**SUNDRY NOTICES AND REPORTS ON WELLS**  
**Do not use this form for proposals to drill or to re-enter an**  
**abandoned well. Use Form 3160-3 (APD) for such proposals.**

8. Well Name and No.  
Shugart A #6

9. API Well No.  
30-015-26438

**Permanent Abandonment of Federal Wells  
Conditions of Approval (LPC Habitat)**

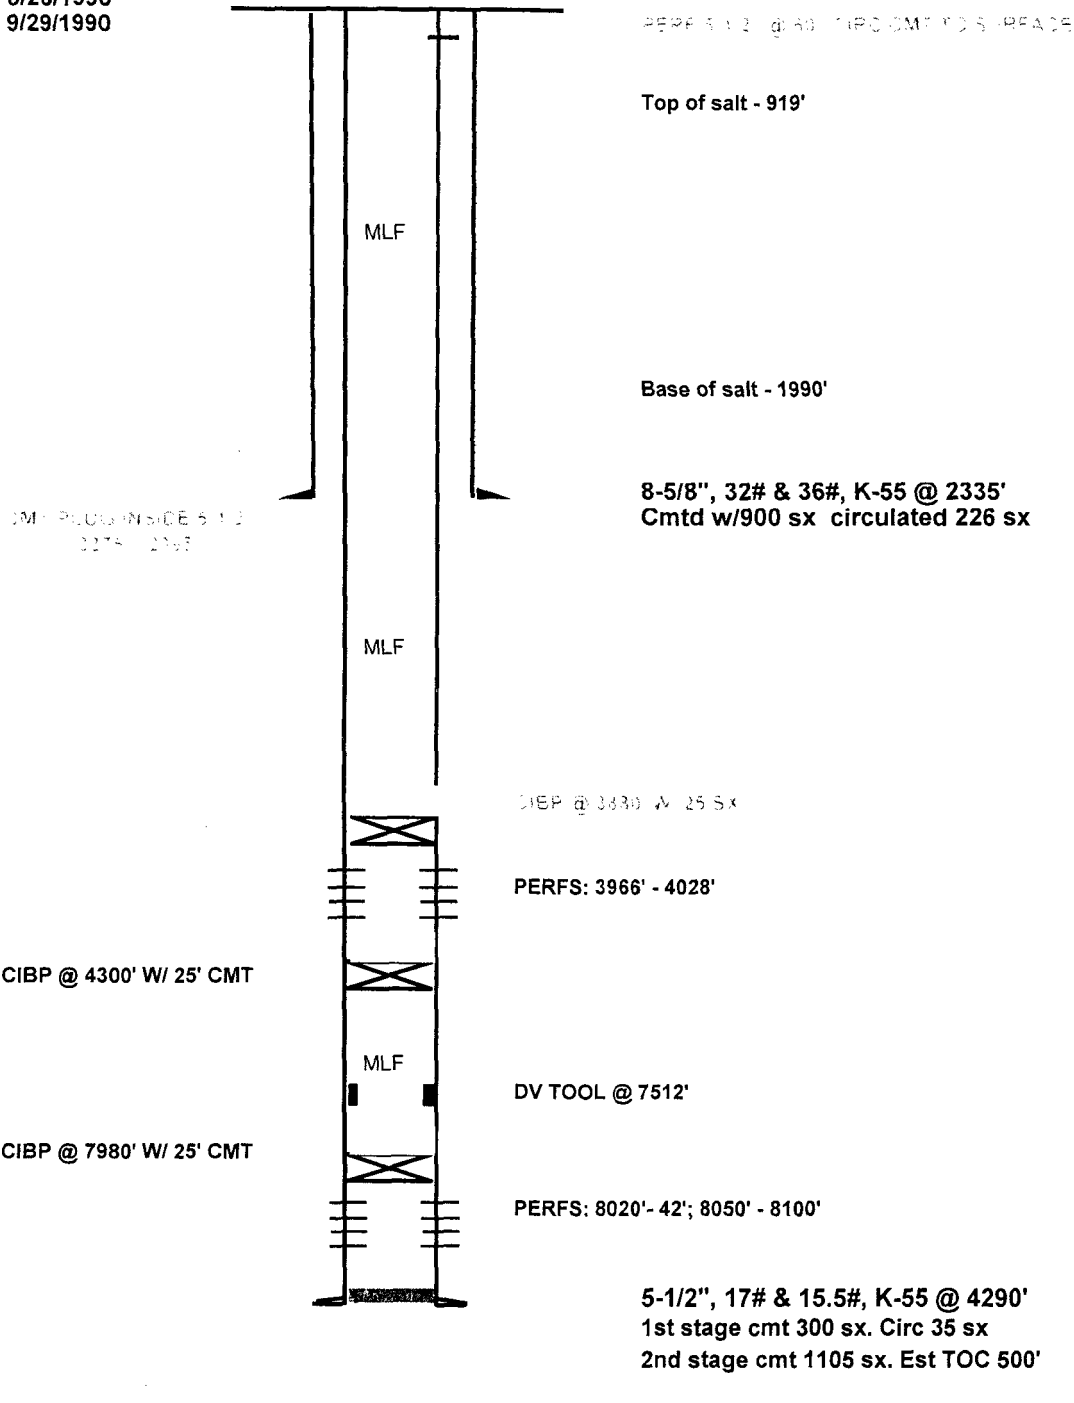
See changes - below

Drill out cmt & CIBP. clean hole to 7562. Spot cmt to 7412. WOC Tag.  
Spot plug from 5746 - 5596. Spot plug from 4960 - 4810. Go to Step 2.

Below ground level Dry Hole Marker Required.
